STATE OF MAINE
DEPARTMENT OF HUMAN SERVICES
AUGUSTA, MAINE 04333

SUBJECT: Figoli property, Eight Rod Road, Augusta

SUBJECT: Denial of New System Variance Request, Figoli property, Eight Road
Road, Augusta

NEW SYSTEM VARIANCE REQUEST

SUBSURFACE WASTEWATER DISPOSAL PLAN

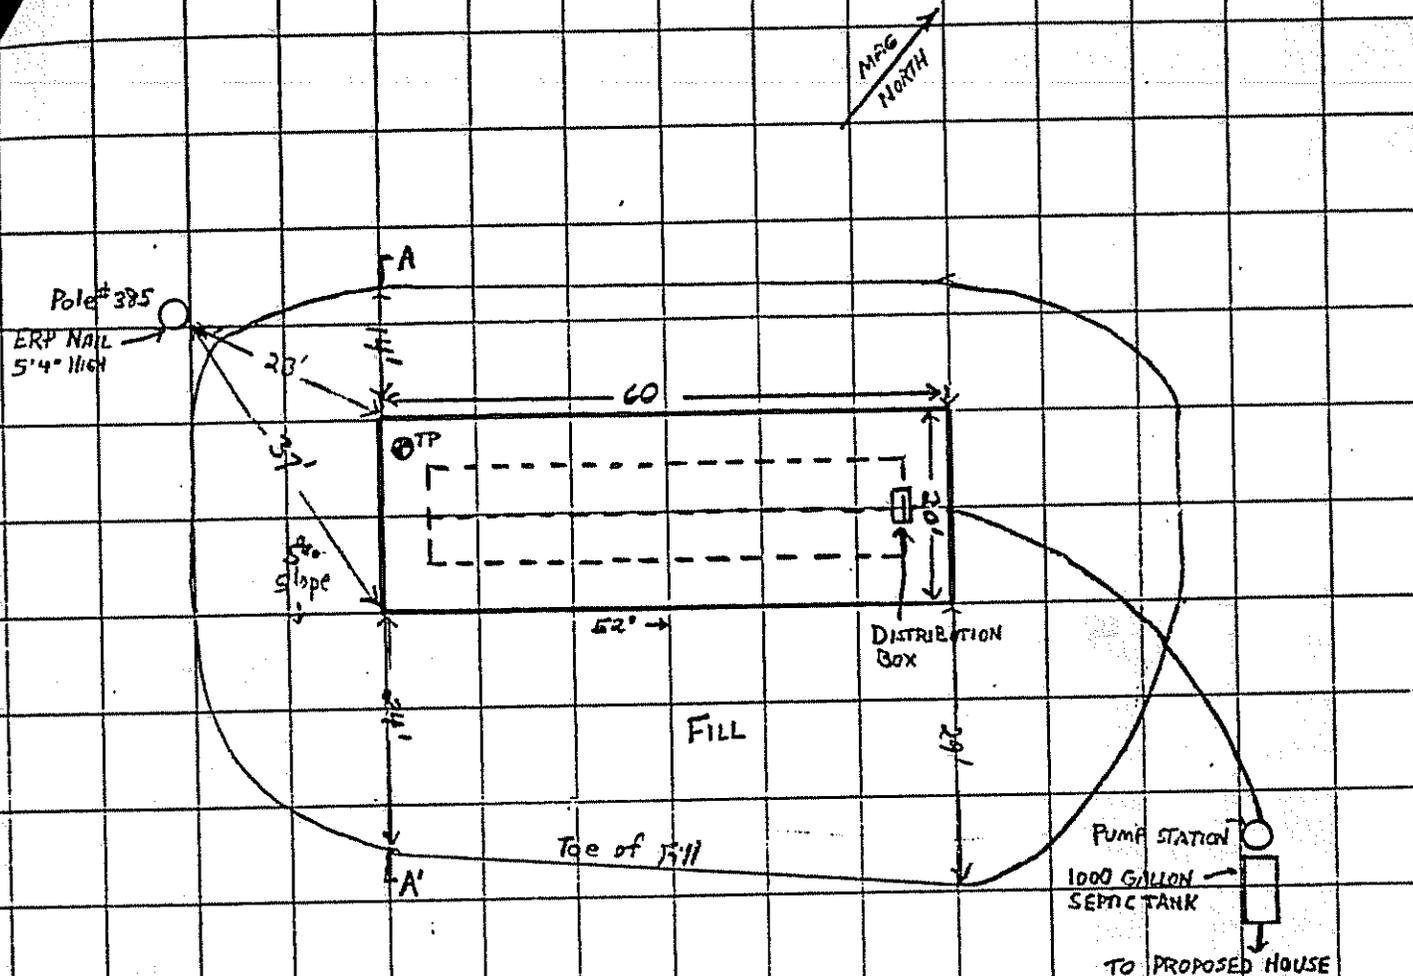
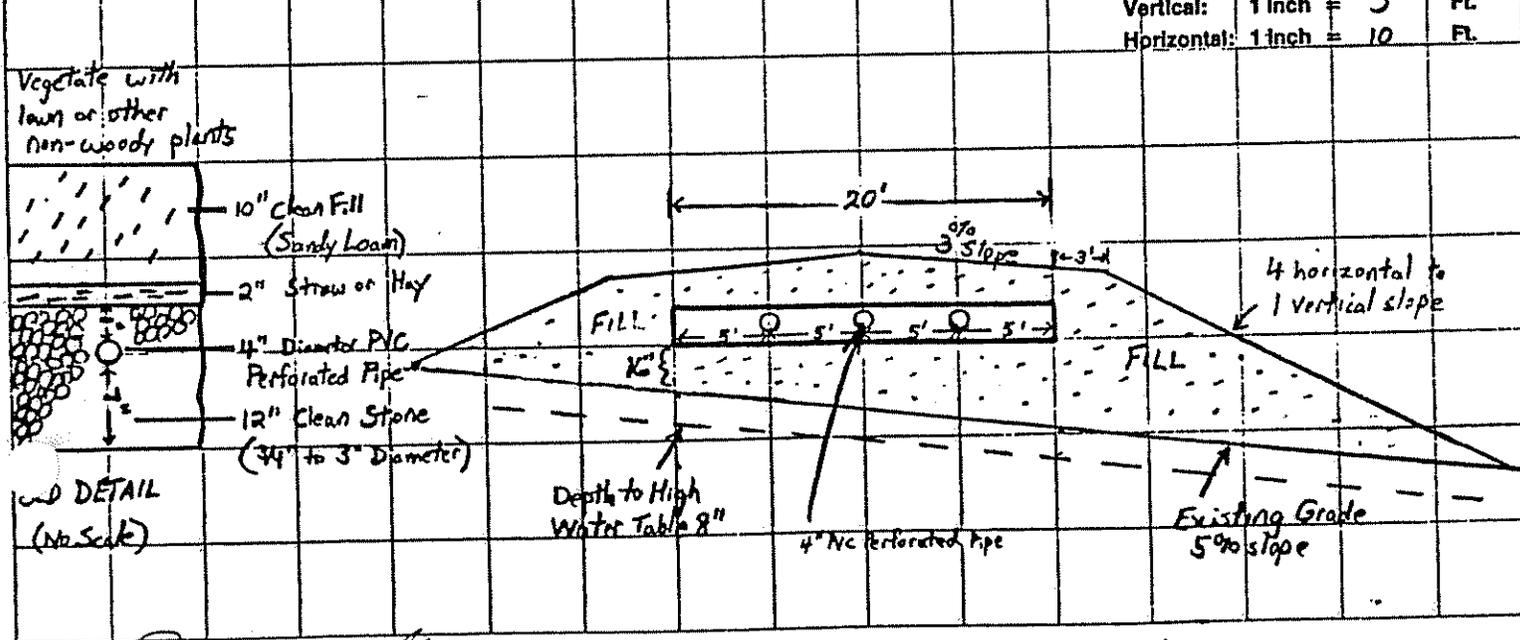
Your application indicates the installation of a pressure distribution system. However, your design does not show the specified network of piping throughout the disposal area to uniformly distribute the wastewater.

I suggest you contact your site evaluator, Donald Witherill, to make the necessary changes. Upon receipt of this information, your review will continue.

Your application was revised on August 17, 1988 by Mr. Witherill, S.E. and shows a curtain drain instead of the pressure distribution network.

Based on the information submitted and the revised information, this office hereby recommends approval of the variance request, with revisions.

Mr. Witherill, S.E. shall be retained to establish the system location and elevation at the time of construction as well as the curtain drain location.
